Subject: AP1000 COL Response to Request for Additional Information (TR 36)

Response to Request for Additional Information on Technical Report No. 36

RAI Response Number: RAI-TR36-012

Figure 6.3-10 2-Inch Cold Leg Break, RCS Pressure

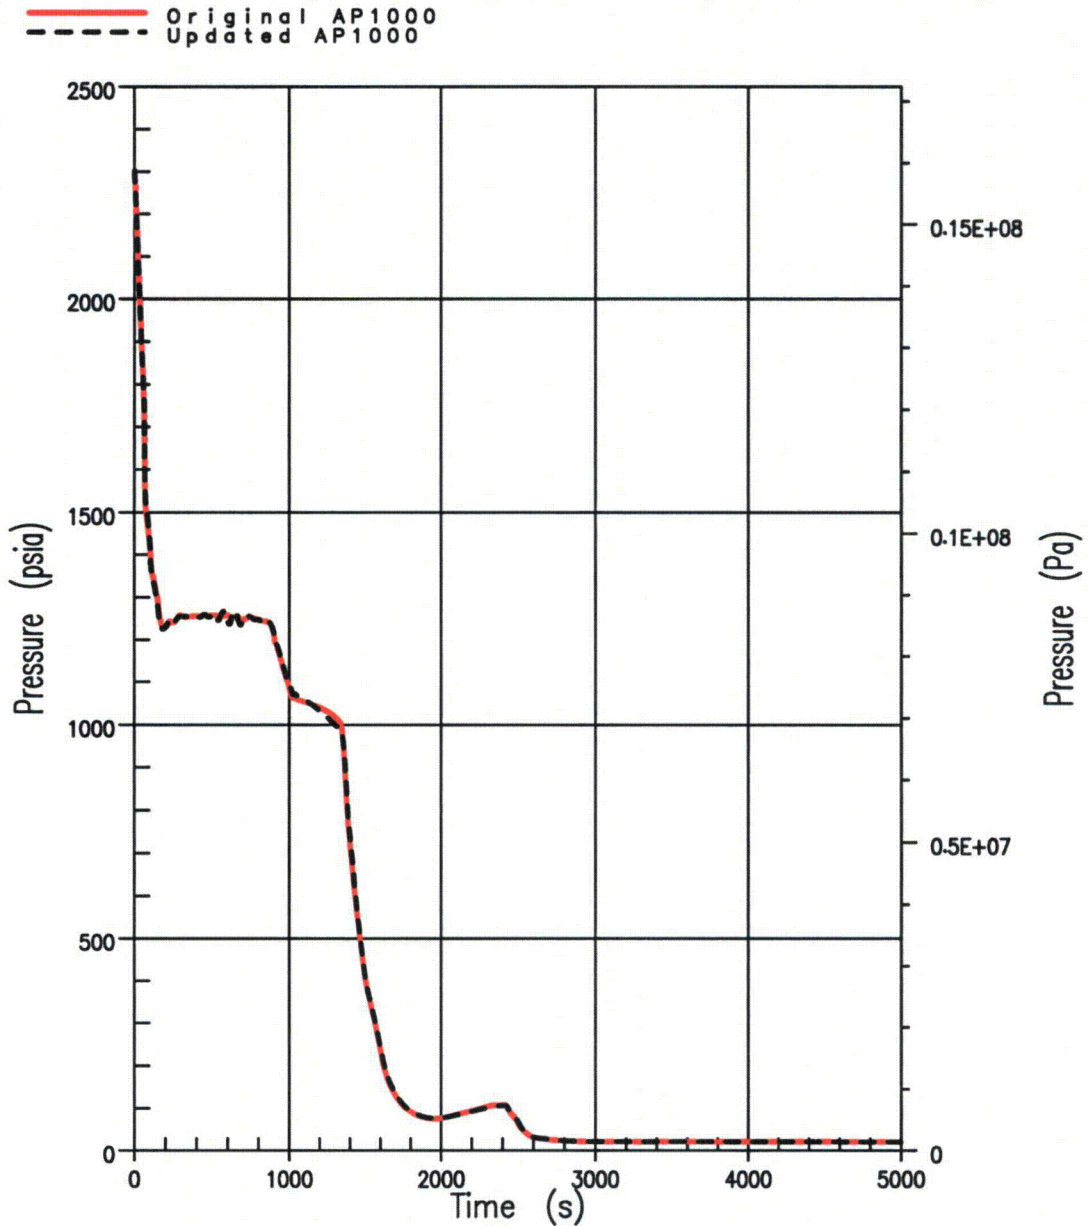
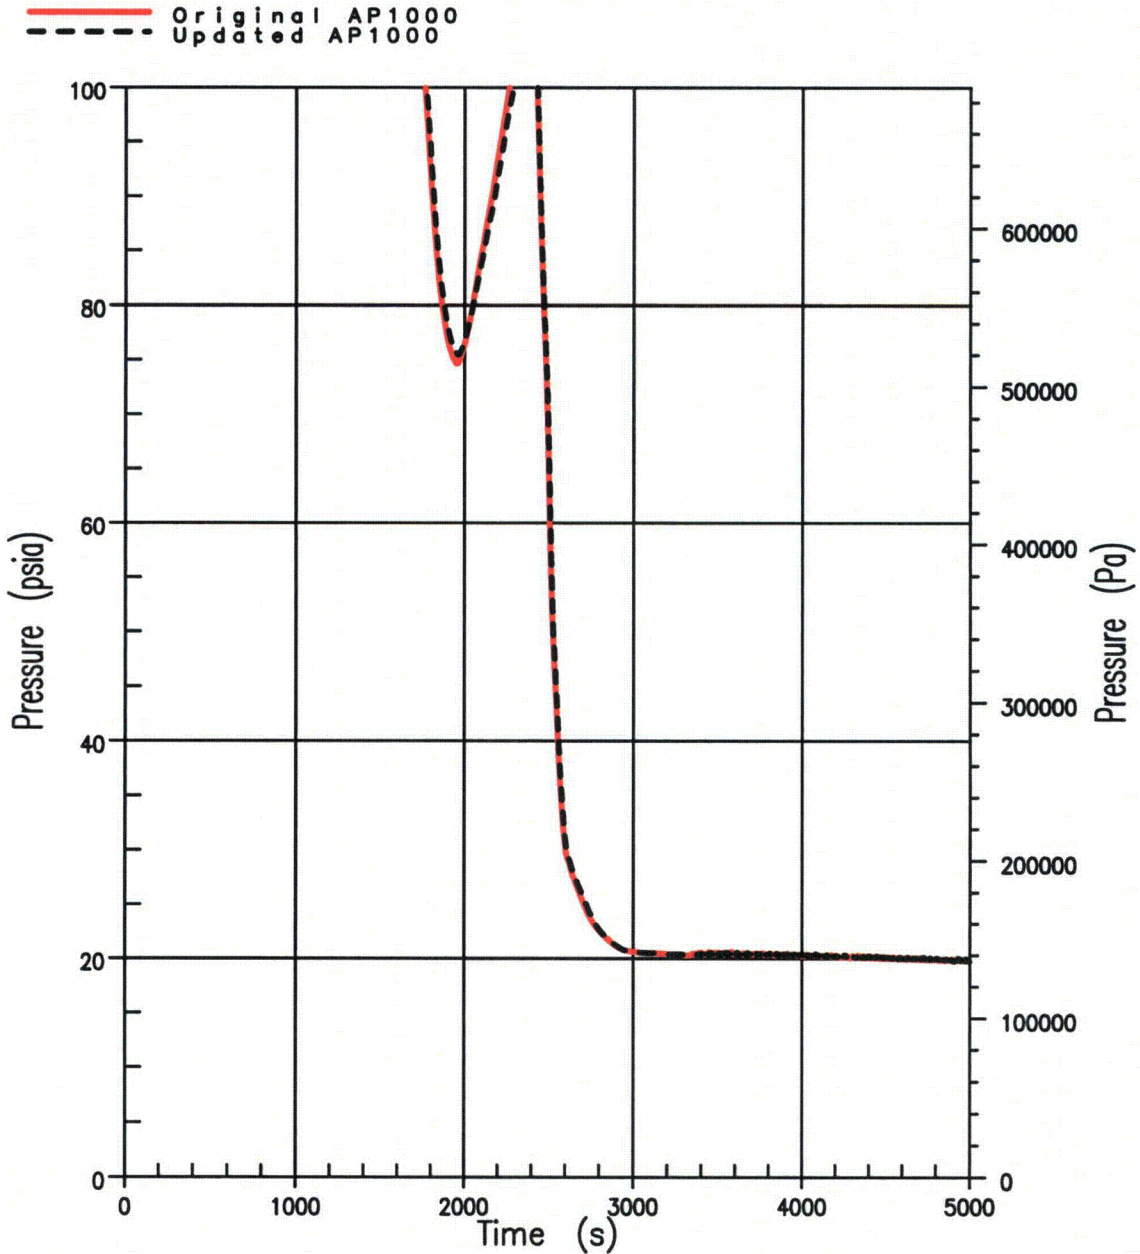
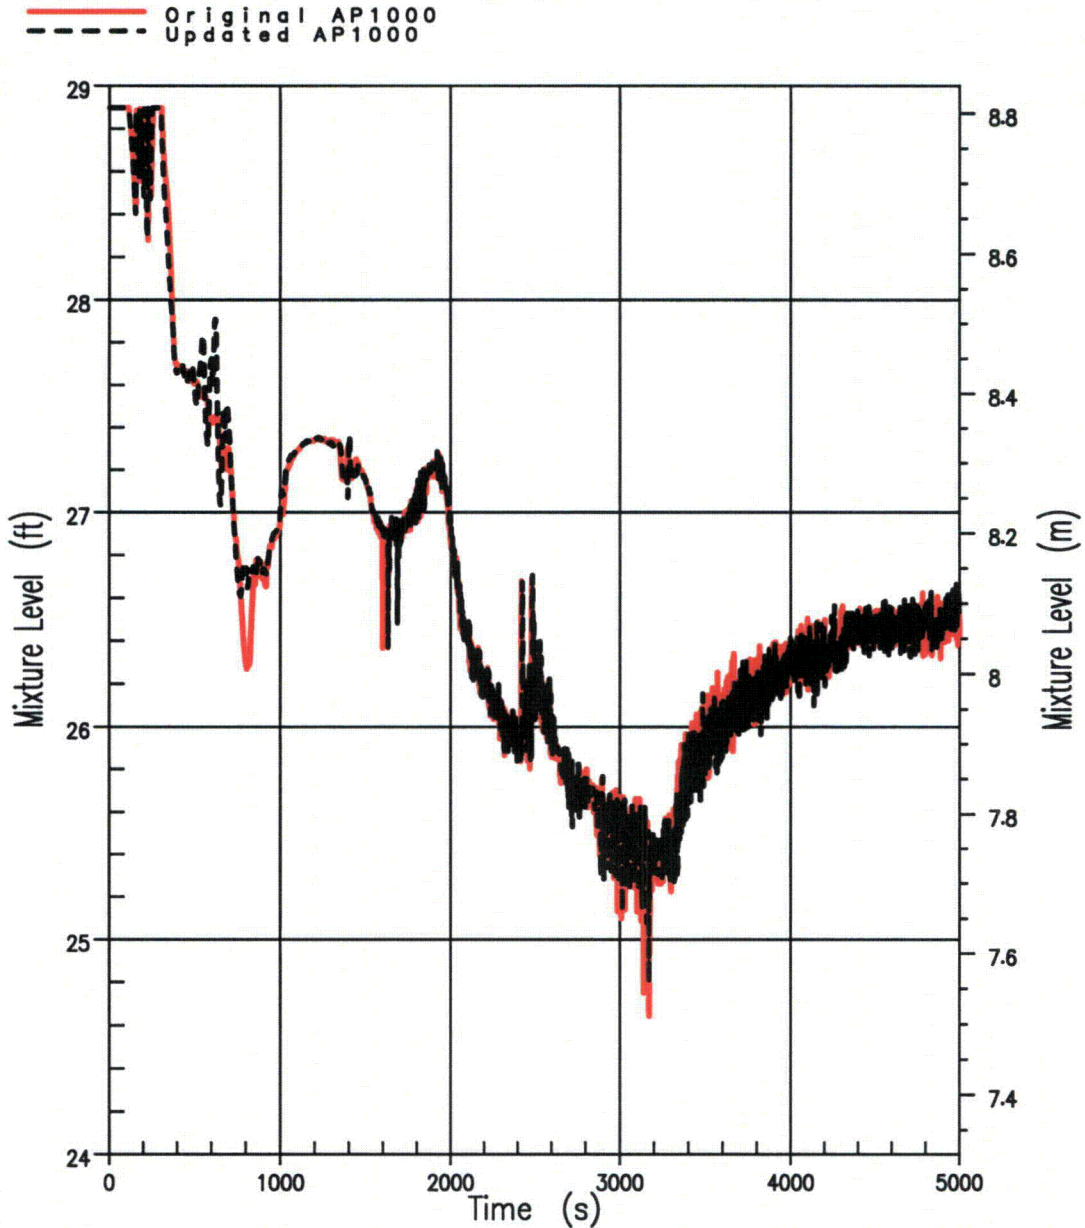
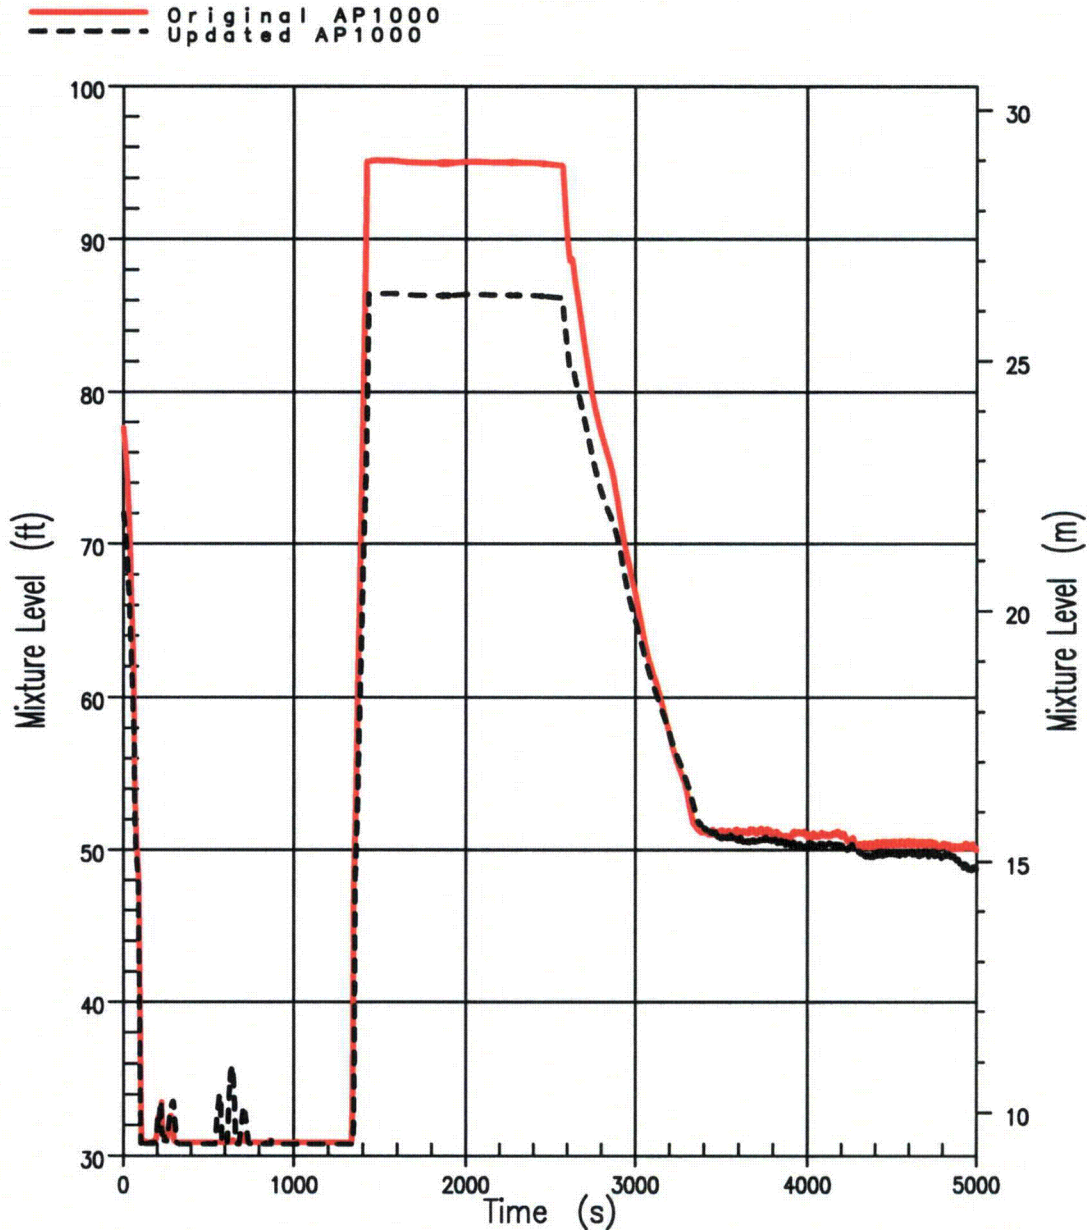
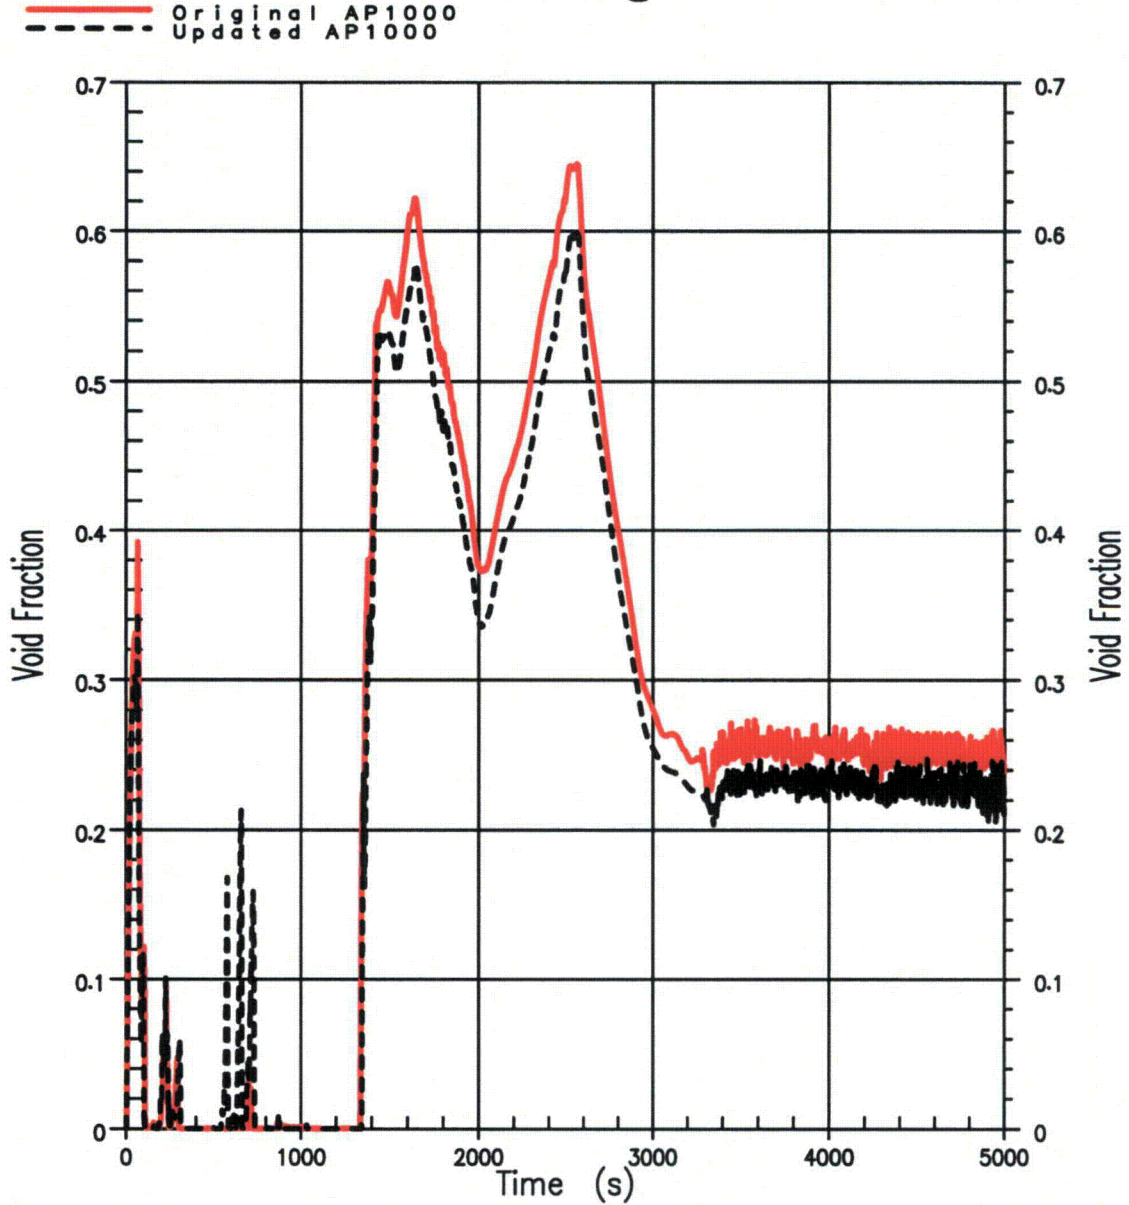
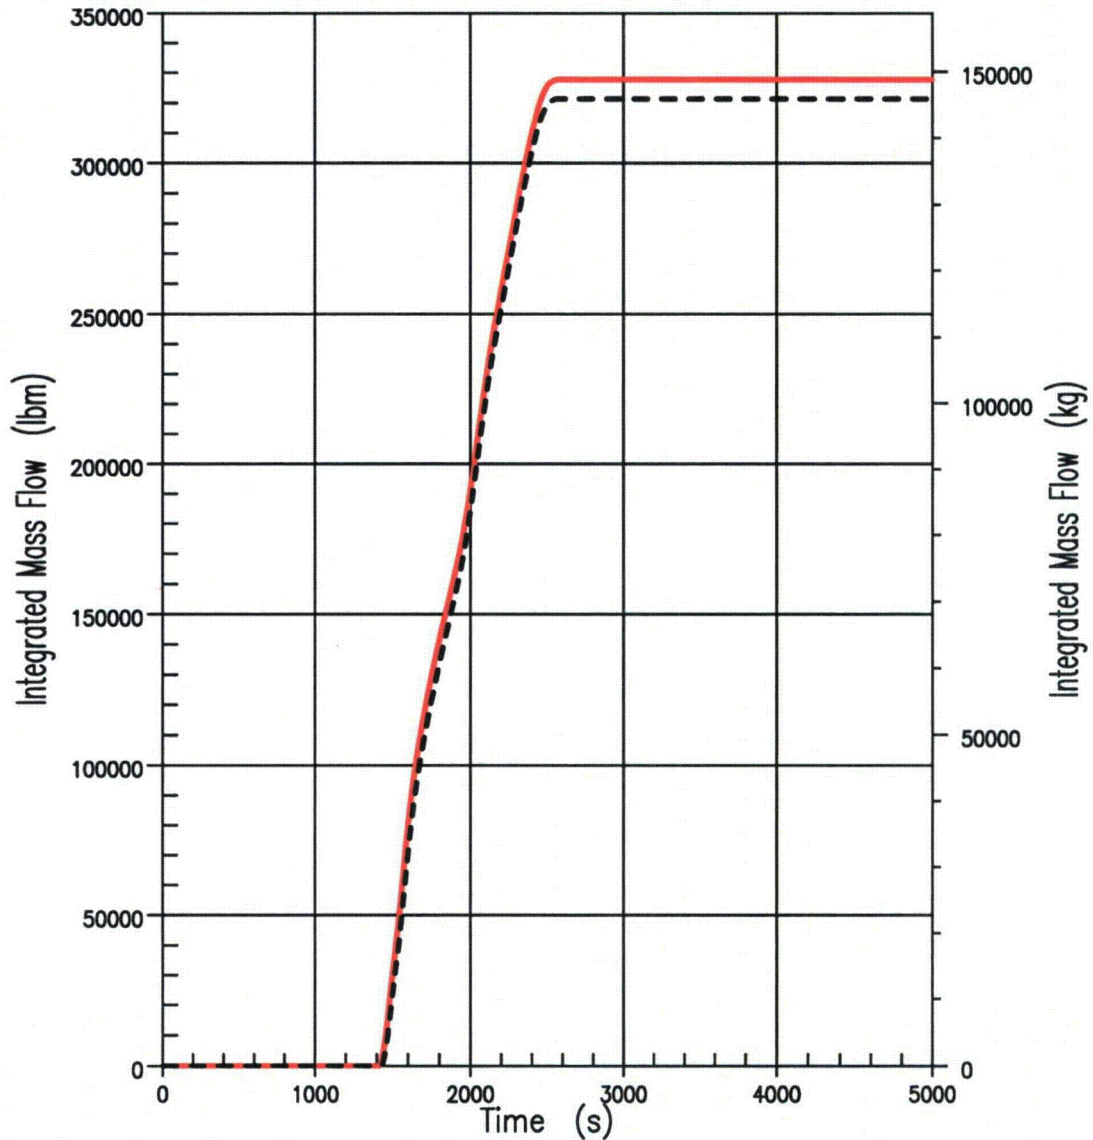
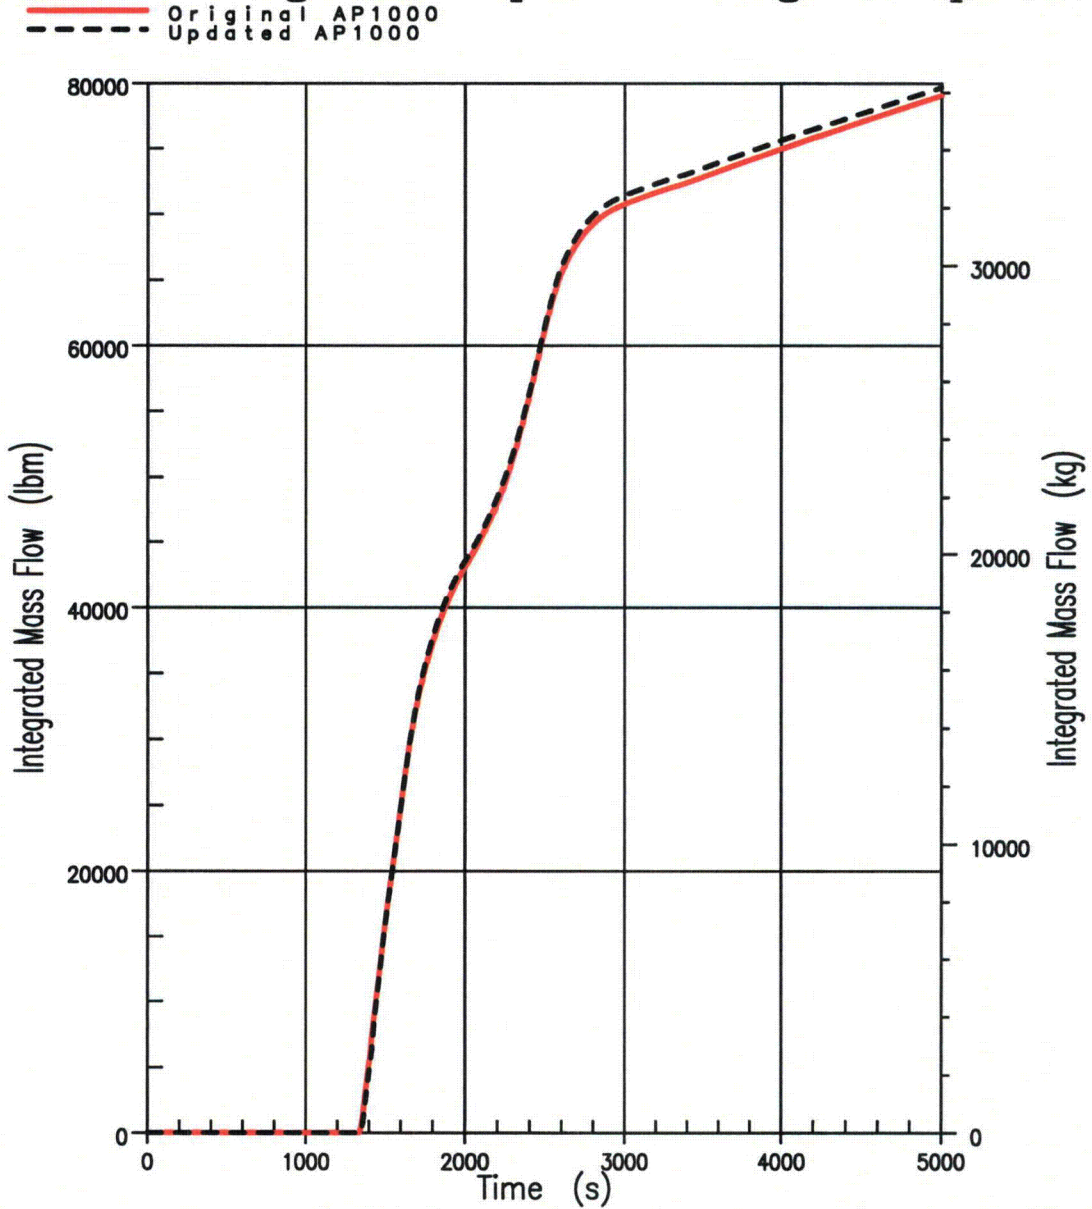
The pressurizer changes affect many parameters such as the cross-sectional area of the pressurizer, pressurizer vessel height, initial pressurizer water level, pressurizer setpoints, ADS stages 1, 2, and 3 elevation and pressurizer heater length. We are concerned about the combined effects of the values changed for the above parameters on the thermal hydraulic response during transient and accident conditions. We determined that the qualitative statement in the RAI response is not sufficient to resolve the RAI issue. We request Westinghouse perform the quantitative analyses for the limiting event for each of the following Standard Review Plan chapter 15 event categories:

Table 6.3-2 and Figures 6.3-10 through 6.3-19 present a comparison of the 2-Inch Cold Leg break simulations. The results again demonstrate the effect of the change in the pressurizer tank diameter, that being the decrease in both the Pressurizer Mixture Level (Figure 6.3-13) and Pressurizer Void Fraction (Figure 6.3-14). This subsequently reduces the Automatic Depressurization System (ADS) Stage 1-3 liquid discharge (Figure 6.3-15) and increases the ADS 1-3 vapor discharge (Figure 6.3-16). The overall effect being slightly more Reactor Coolant System (RCS) inventory in the RCS for a majority of the transient simulation period (Figure 6.3-19). No significant changes in the RCS Pressure (Figures 6.3-10 and 6.3-11), Core Mixture Level (Figure 6.3-12) and DVI injection characteristics (Figure 6.3-17 and 6.3-18) are observed as a result of the design change implementation.
